DART SERVICE INSTRUCTION

TO AMEND INSTALLATION INSTRUCTIONS IIN-D135-692 REV. B AND
INSTRUCTIONS FOR CONTINUED AIRWORTHINESS ICA-D135-692 REV. 1

REF. FAA STC: SR01042SE

FIGURE 1: MODIFICATION OF D135-692-011 INSTALLATION
NOT TO SCALE

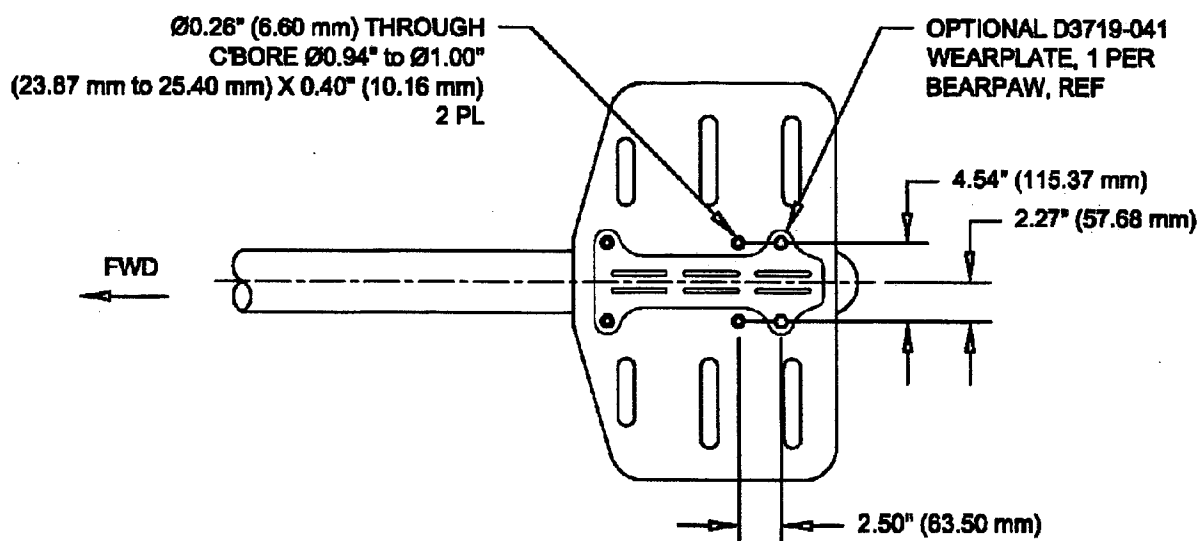
The purpose of this Dart Service Instruction is to allow customers with D135-692-011 Bearpaws at CHG 002 and earlier to modify the D3049-1 Bearpaw to relocate the aft most D2519 Clamp and D2182B060 Rubber Cushion by up to 2.5" (63.5 mm) further forward to avoid interference with the snow ski provisions on the OEM skidtubes. At CHG 003 and later, the D3049-1 Bearpaw is supplied with the provisions to relocate the clamp and cushion.

NOTE: For D135-692-011 Bearpaw Kits at CHG 002 and prior, drill Qty 2x Ø0.26" (6.60 mm) holes through the D3049-1 Bearpaws as indicated in Figure 1 of this Dart Service Instruction. Counter bore the holes on the underside of the bearpaws Ø0.94" to Ø1.00" (23.87 mm to 25.40 mm) and to a depth of 0.40" (10.16 mm).

2.2 If installing the D135-692-011 Bearpaw Kit **with** the D135-692-041 Wearplate Kit, align the D3719-041 Wearplate under the D3049-1 Bearpaw as shown in Figure 1 of this service instruction and install the bearpaw and wearplate onto the skidtube using the hardware shown in Figure 2, 3 and 4 of this service instruction.

2.3 If installing the D135-692-011 Bearpaw Kit **without** the D135-692-041 Wearplate Kit, align the D3049-1 Bearpaw as shown in Figure 1 of this service instruction and install the bearpaw onto the skidtube using the hardware shown in Figure 5 of this service instruction.
